Visual Impact Assessment; Amended REA

Tahmoor South

**Tahmoor South – Reject Emplacement Area design amendment**

**Figure 14A**  
Proposed amended REA locality plan (October 2019)

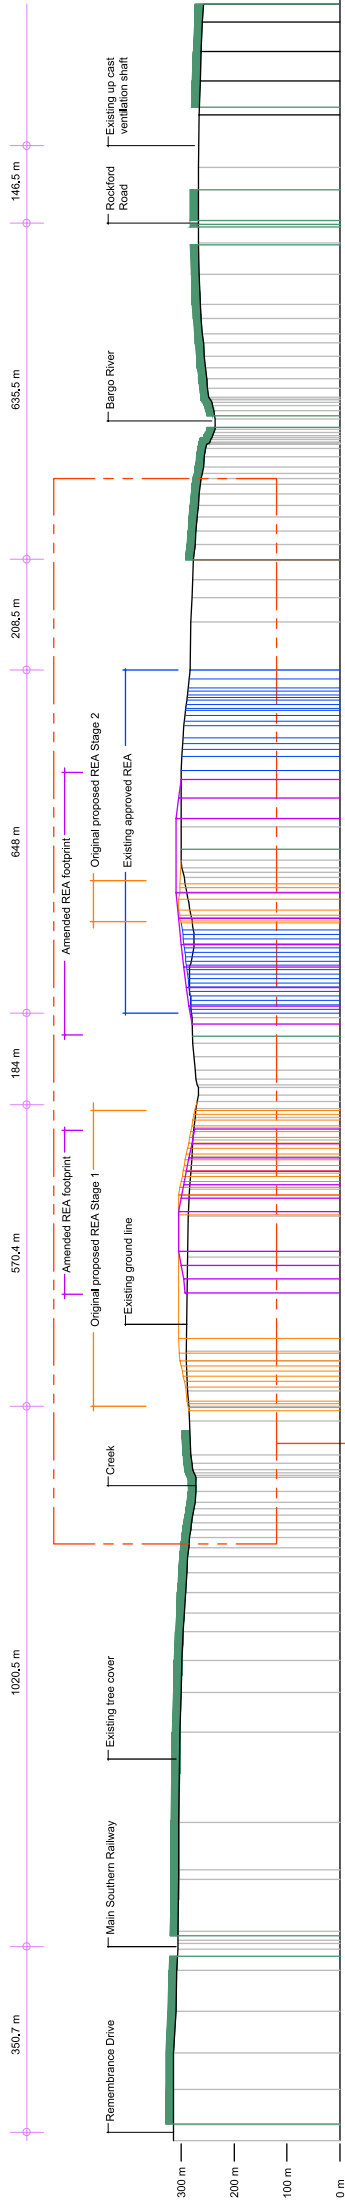
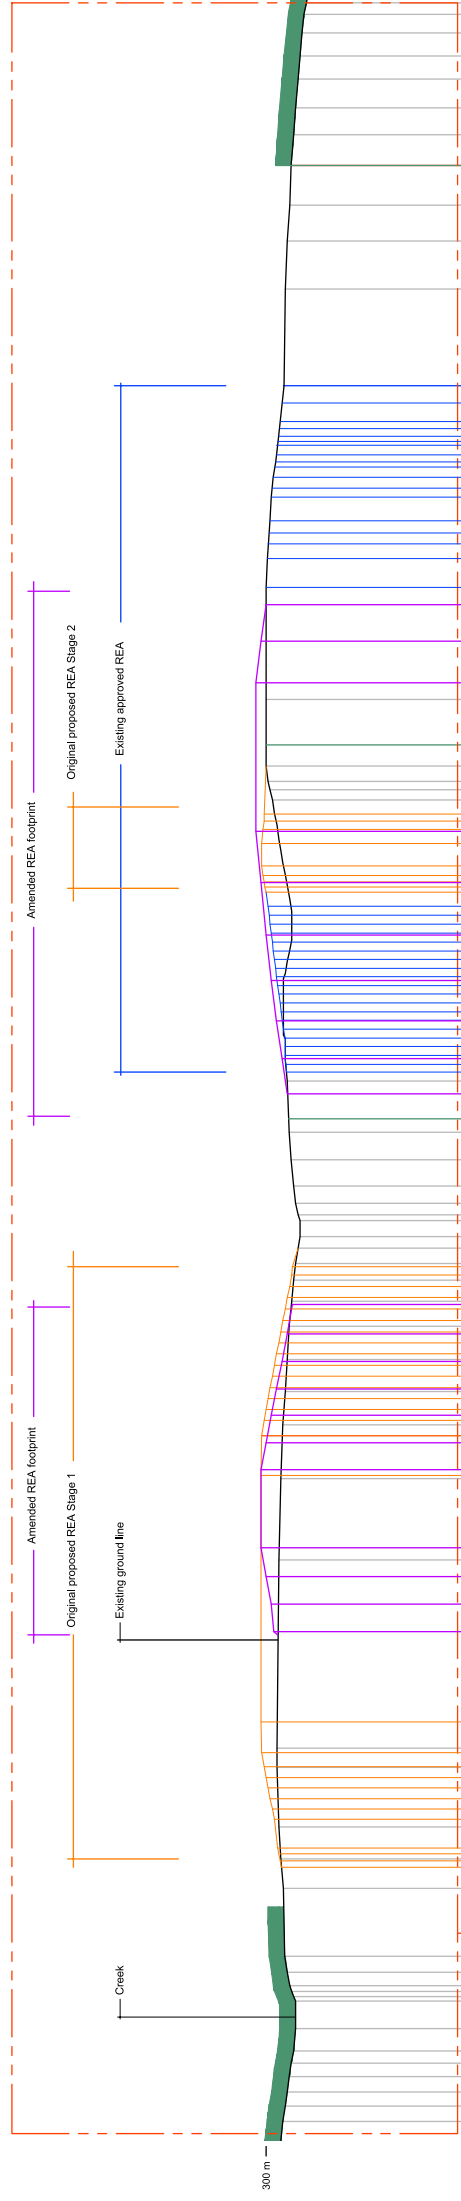
The Amended Project Report includes a proposal to decrease the original proposed Reject Emplacement Area (REA) Stage 1 and 2 footprint, and to increase the final design level by 5 metres from the original proposed 305 metres AHD to 310 metres AHD.

The VIA cross sections A and B have been updated to illustrate the proposed amended REA footprint and the 310 metre AHD final design level. The cross section locations (and amended REA footprint) are illustrated in the appended Figure 14A, and cross sections A and B in Figures 15A and 16A respectively.

Having reviewed the information provided with regard to the proposed amended REA, GBD confirm that the potential for an increase in the level of REA visibility will be restricted by existing landscape characteristics surrounding the proposed amended REA. In our professional opinion, the proposed amended REA will not result in a level of visual effect or visual significance over and above the low impact determined in the VIA report.

**Figure 15A**  
Cross Section A north east to south west across existing approved and proposed amended REA

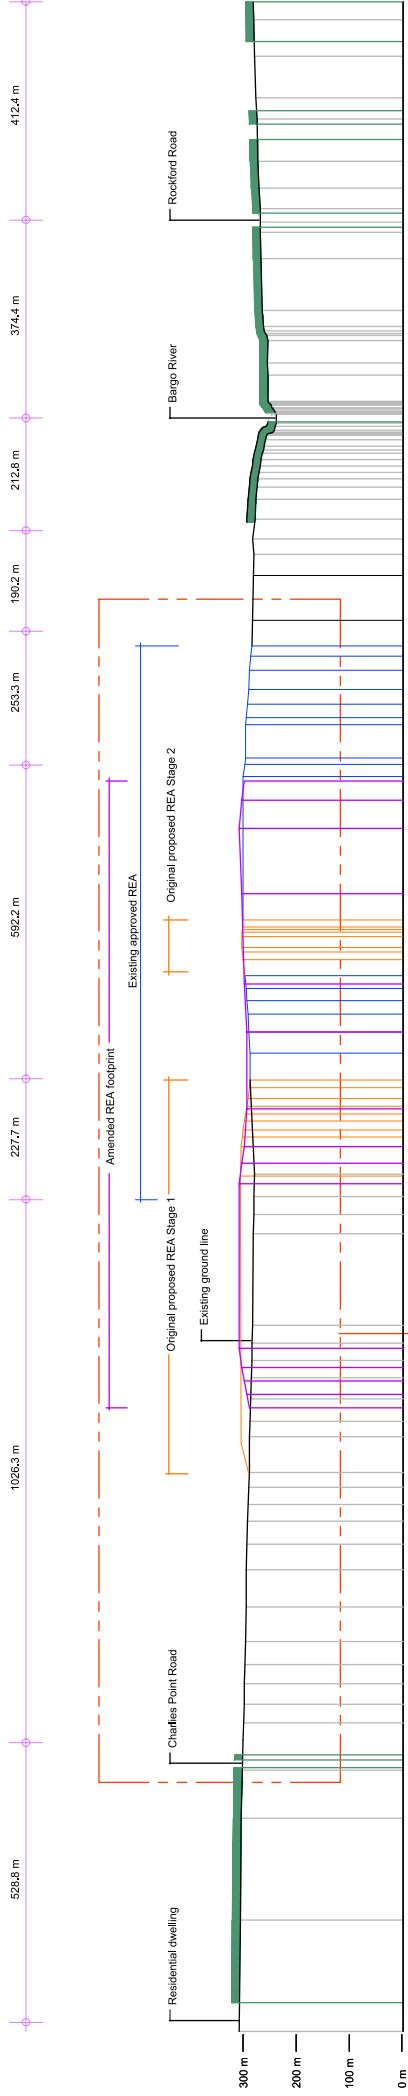
The proposed amended REA footprint, and amended cross sections, illustrate the limited potential for an increase to the low level of visual effect and significance determined in the VIA. The level of visual effect and significance is mitigated by factors identified in the VIA, which include the:
